BAW-10172NP-A  
Revision 0  
December 1989

MARK-BW MECHANICAL DESIGN REPORT

SUBJECT: ACCEPTANCE FOR REFERENCING BABCOCK & WILCOX TOPICAL REPORT  
BAW-10172P, "MARK-BW MECHANICAL DESIGN REPORT" (TAC NO. 68873)

**SAFETY EVALUATION OF BABCOCK & WILCOX  
TOPICAL REPORT BAW-10172P,  
"MARK-BW MECHANICAL DESIGN REPORT"**

FIGURE 5-3

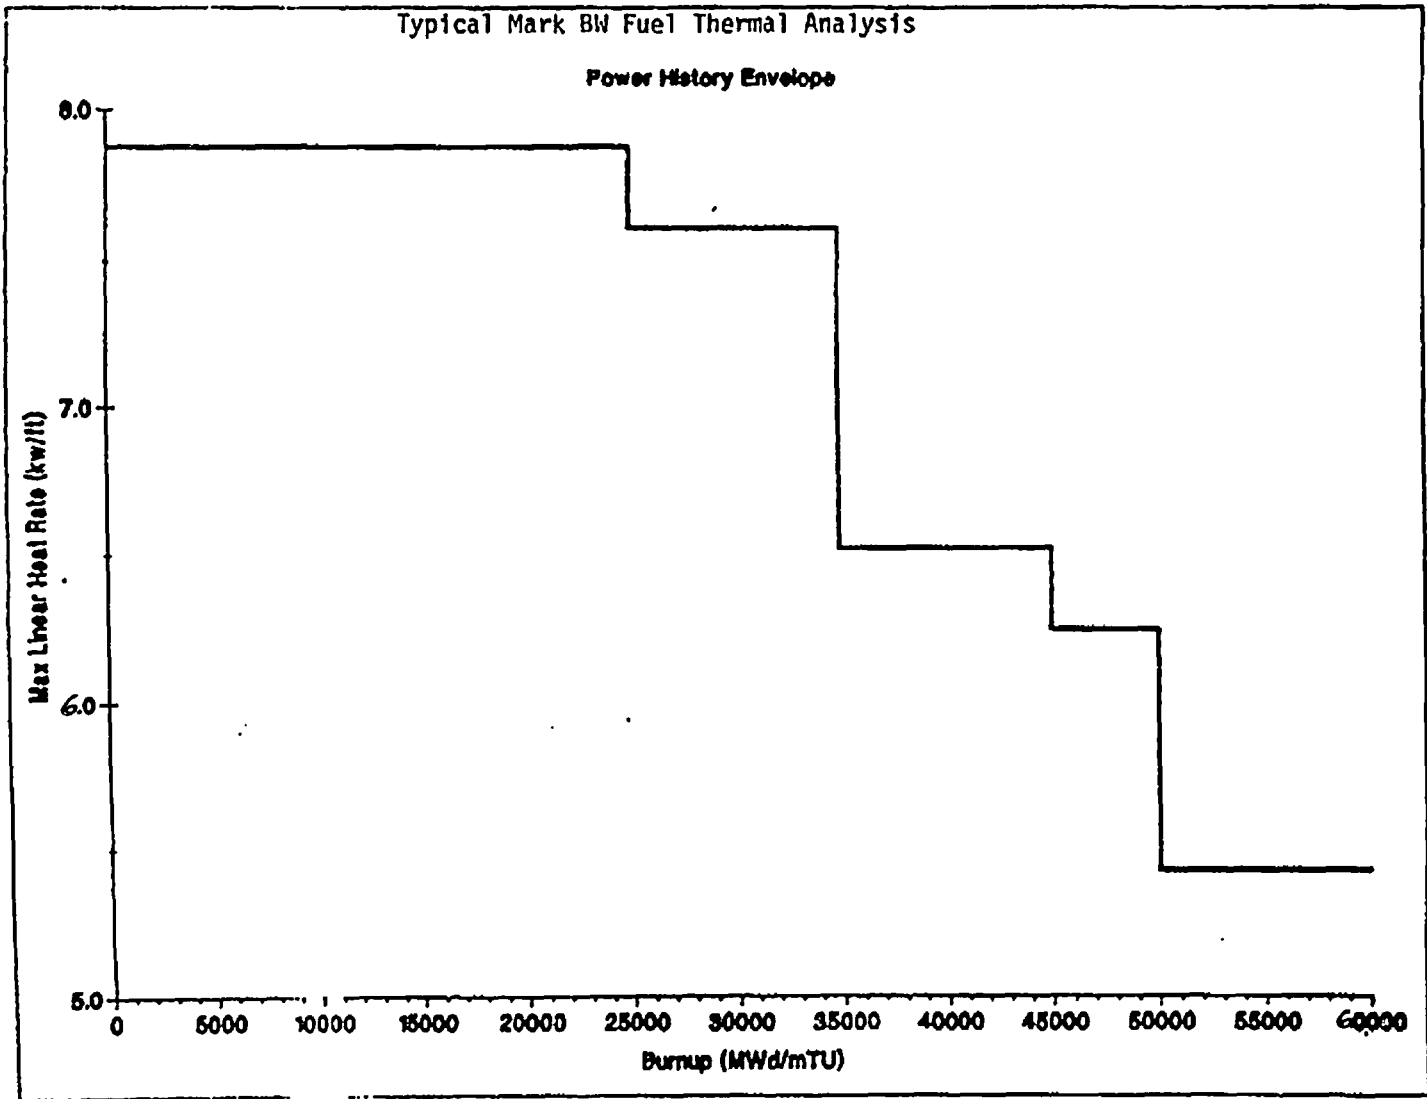
Question 10: The power history envelope for the Mark-BW design in Figure 5-3 does not match the envelope for this design provided in Figure I-13 of Appendix I in the TAC03 documentation. Why is there a difference between these power history envelopes? How is the power history envelope in Figure 5-3 determined? Will the power history envelope in Figure 5-3 be used for internal rod pressure analyses? Will the rod pressures for the Mark-BW design exceed system pressure at the maximum burnups requested?

Response: The power history envelope for the Mark-BW design shown in Figure 5-3 of BAW-10172P was developed using methods described in BAW-10141P-A, rev. 1, and BAW-10153P-A. This power history was used in calculations performed with TAC02 to produce the fuel temperature and internal pressure predictions shown in Figures 5-4 and 5-5 of BAW-10172P. The power history envelope shown in Figure I-13 of the TAC03 documentation (8) represents a later update, developed with a slightly different method (i.e. uncertainty adjustments are treated differently). The application of this envelope to the analysis of fuel performance for any specific fuel cycle is subject to the same criterion as the TAC02 envelope, namely that it must be demonstrated to bound the predicted fuel rod power vs burnup for the most limiting rods in the core. All future Mark-BW fuel rod thermal performance analyses will use TAC03. This envelope, or similar envelopes developed with the same procedure, will be used for the prediction of fuel rod internal
